Sydney CBD and South East Light Rail Environmental Impact Statement- Comments on Safety

Figure 1. The Devonshire Street transport axis: Pedestrian usage is currently high, cycling could be enhanced by correct design of the Light rail proposal

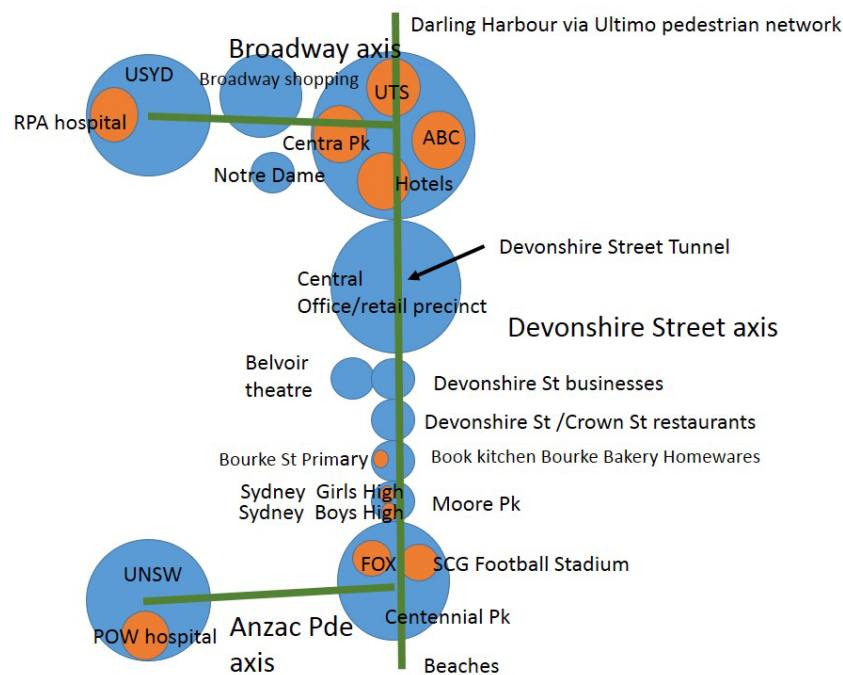
precincts are commercial, educational, recreational, health care, residential, commercial, hotel and other retail and service industries. The usage by pedestrians is high and could be higher given a clear connection to Moore Park along Parkham Street that is not currently well delineated, but will be if the light rail proposal goes ahead. Usage by cyclists of this corridor is currently impeded by the lack of a good cycle connection across Central station as well as the lack of a well defined link through Parkham Street. To achieve the cycle link through central station, the Devonshire Street pedestrian tunnel could be made more cycle friendly. There is a need for an east-west cycle crossing of the city to allow cyclists to avoid the hazardous route along Cleveland Street. Cleveland Street is not an alternative to the Devonshire Street corridor as it provides poor conditions for cyclists because of conflict with motorised road traffic and also has a poor amenity for pedestrians. The light rail proposal provides an opportunity to enhance the amenity of this corridor for cyclists.

A major deficiency of the design of the proposal in the Devonshire street corridor is the lack of incorporation of a cycle path that will lead an adverse impact on cycling. Cycling is a sustainable personal transport solution for linking the educational, residential, commercial, retail and recreational centres along the Devonshire Street corridor.
